Item Name: Replacement Exterior Window For -111

DESIGN		DART AEROSPACE LTD	
DRAWN		HAWKESBURY, ONTARIO, CANADA	
CHECKED		DRAWING NO.	REV. C
MFG. APPR.		D3290	SHEET 2 OF 2
APPROVED		TITLE	SCALE
DE APPR.		REPLACEMENT WINDOW ASSEMBLY 1:1	
DATE	07.07.24	COPYRIGHT © 2004 BY DART AEROSPACE LTD	
THIS DOCUMENT IS PRIVATE AND CONFIDENTIAL AND IS SUPPLIED ON THE EXPRESS CONDITION THAT IT IS NOT TO BE USED FOR ANY PURPOSES OR COPIED OR COMMUNICATED TO ANY OTHER PERSON WITHOUT WRITTEN PERMISSION FROM DART AEROSPACE LTD.

DRAWING NO. D3290	TITLE REPLACEMENT WINDOW ASSEMBLY	REV. C	DART AEROSPACE LTD ENGINEERING ORDER		D.E.O. NO. D3290-C-1	SHEET NO. SHEET 1 OF 1	SCALE NTS
DRAWN <i>Q</i>	CHECKED <i>J</i>	MFG. APPR. <i>E</i>	APPROVED <i>MP</i>		DE APPR. <i>MP</i>		
DATE 09.09.18	DATE 09.09.18	DATE 09.09.18	DATE 09/09/21		DATE 09/09/21

D3290-3 WINDOW

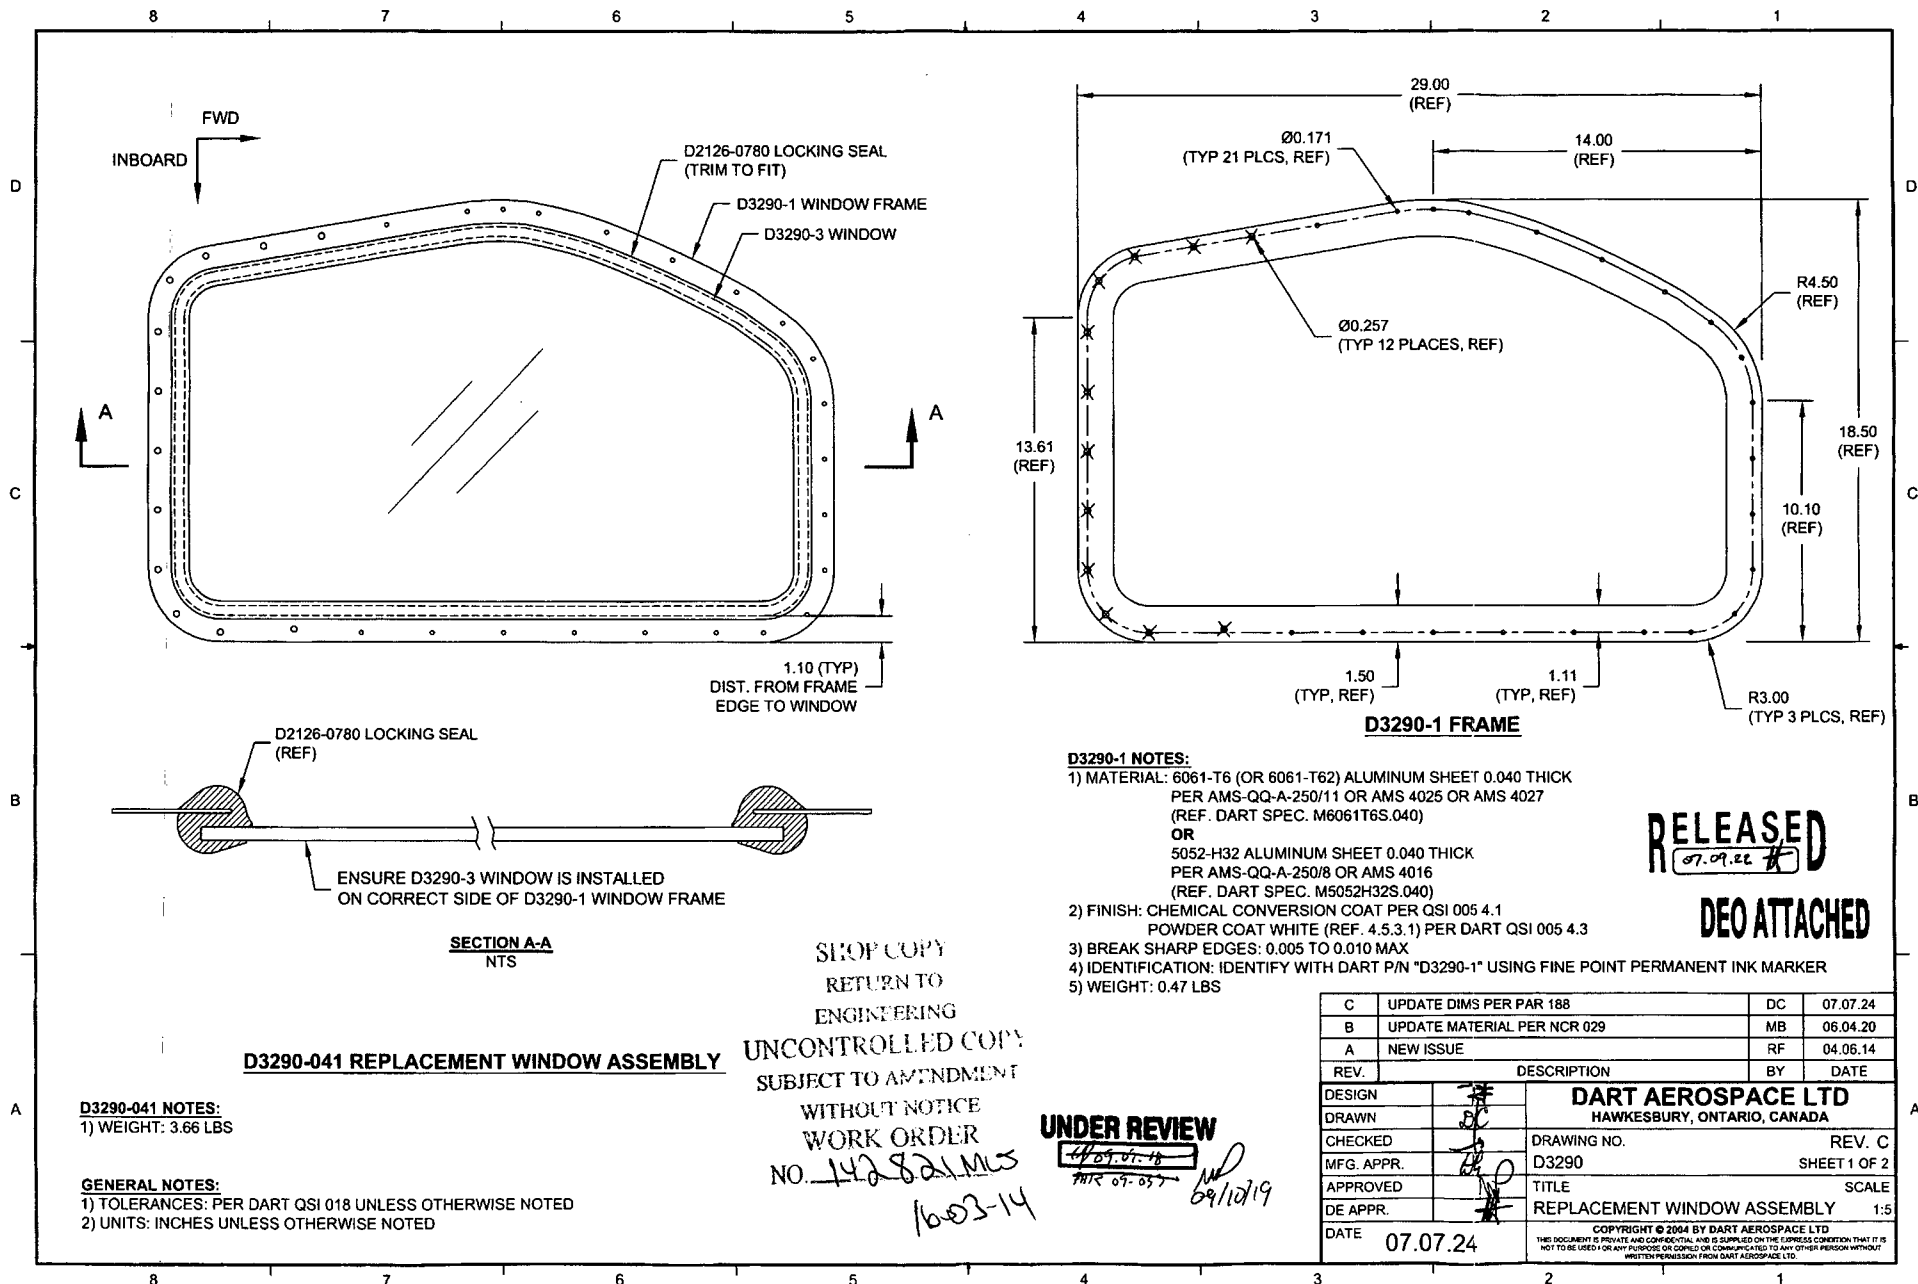
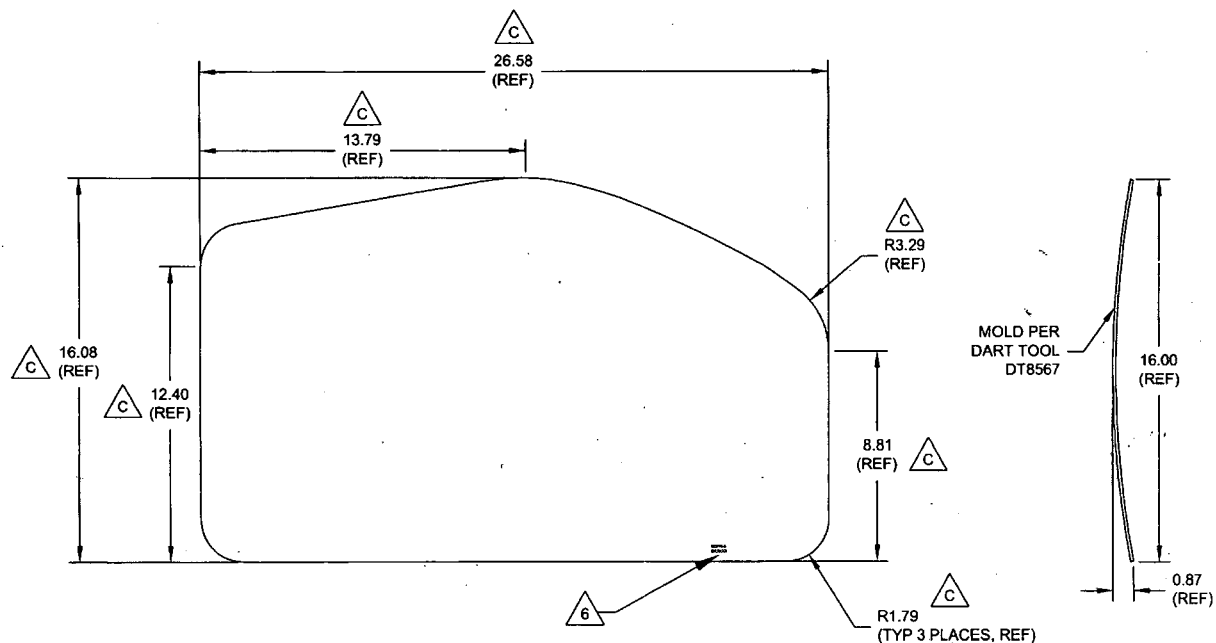
CHANGE MATERIAL THICKNESS OF D3290-1 FRAME TO 0.063 FROM 0.040. REF PAR 09-033.

MATERIAL CALL-OUT OF D3290-1 FRAME ON SHEET 1 IS AMENDED AS FOLLOWS:

- 1) MATERIAL: 6061-T6 (OR 6061-T62) ALUMINUM SHEET ~~0.040 THICK~~ 0.063 THICK (REPLACE)
 PER AMS-QQ-A-250/11 OR AMS 4025 OR AMS 4027
~~(REF. DART SPEC. M6061T6S.040)~~ REF. DART SPEC. M6061T6S.063 (REPLACE)
 OR
 5052-H32 ALUMINUM SHEET ~~0.040 THICK~~ 0.063 THICK (REPLACE)
 PER AMS-QQ-A-250/8 OR AMS 4016
~~(REF. DART SPEC. M5052H32S.040)~~ REF. DART SPEC. M5052H32S.063 (REPLACE)
